SERVICE BULLETIN

INSPECTION, PN 369A7011 LONGITUDINAL MIXER CONTROL ROD; REPLACEMENT OF PN 369D22509-51 DOUBLER WITH 369DSK169-3 REPAIR DOUBLER

500E Model 369E Series Helicopters Serial No. 0001E through 0027E, 0029E through 0036E and 0038E through 0043E.

Figure 1. Interference Check and Rivet Removal; Check for Missing Rivets

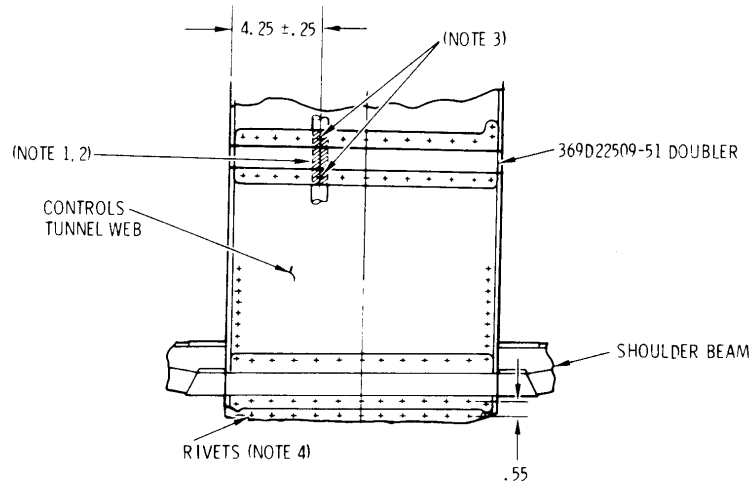
- a. Remove all crew compartment interior trim from controls tunnel (Section 4, HMI Vol 1).
- b. Remove controls access door (Section 2, HMI Vol 1).
- c. Check 369D22509-21 web below shoulder.. beam for presence of 11 rivets as shown in Figure 1. If rivets are missing, install 11 NAS1738B4 rivets as shown.

- d. Release cyclic friction; with hand on rivets, (shown in shaded area of Figure 1) connecting 369D22509-51 doubler to controls tunnel web, move cyclic control stick full forward, then slowly to the full aft position. If any movement of the 369D22509-51 doubler is felt, perform Part II of this Notice. Control rod must be repaired or replaced if any damage is noted. If no movement is detected, complete Part I of this Notice.

- e. Move cyclic stick to full forward position; using portable drill or grinder, carefully drill out or grind heads off any rivets connecting 369D22509-51 doubler to controls tunnel web in area shown in Figure 1. Carefully press rivet shanks out of holes.

1. PLACE FINGERS ON RIVETS IN SHADED AREA WHILE MOVING CYCLIC STICK FULL AFT TO CHECK FOR CONTROL ROD INTERFERENCE.
2. REMOVE ANY RIVETS IN THIS AREA.
3. LEAVE THESE HOLES OPEN. (2 PL)
4. IF RIVETS NOT INSTALLED, INSTALL 11 NAS1738B4 RIVETS AS SHOWN.

Figure 2. Fabrication of Repair Doubler Channel

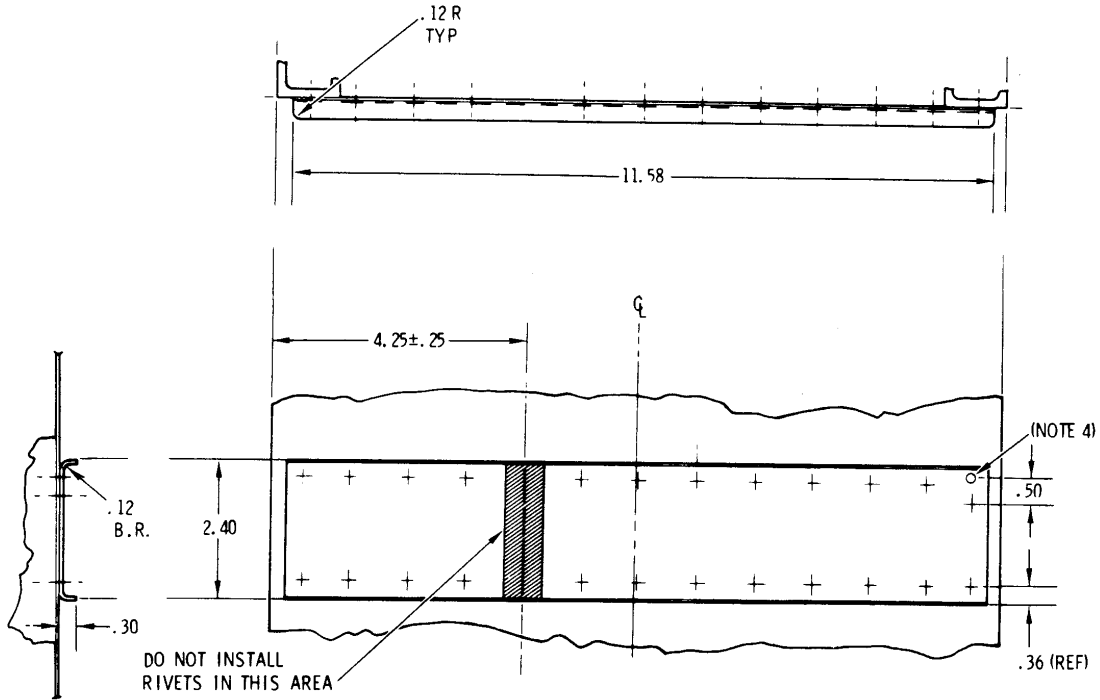
- a. Remove control tunnel cover boot. Disconnect and remove longitudinal mixer control rod (Section 7, HMI Vol 1). Ensure that other control rods are in the full aft position.
- b. Using portable drill or grinder, carefully drill out or grind heads off rivets attaching 369D22509-51 doubler. Carefully press rivets out of holes.
- c. Fabricate 369DSK169-3 repair doubler channel from 2024-T3 aluminum alloy sheet, 0.32 inch thick, as shown in Figure 2. Apply zinc chromate primer to all bare metal; paint to match helicopter finish.
- d. Using removed doubler as template, drill holes in 369DSK169-3 repair doubler to match existing rivet pattern; do not drill holes in area shown in Figure 2 (three places). Center 369D22509-51 doubler to 369DSK169-3 repair doubler when drilling holes.

1. FABRICATE FROM 0.032 INCH THICK, 2024-T3 ALUMINUM ALLOY SHEET.
2. RELOCATE RIVET HOLE FROM HOLE IN 369D22509-51 AS SHOWN.
3. CENTER 369D22509-51 DOUBLER TO REPAIR DOUBLER AND MATCH DRILL HOLES EXCEPT AS NOTED.
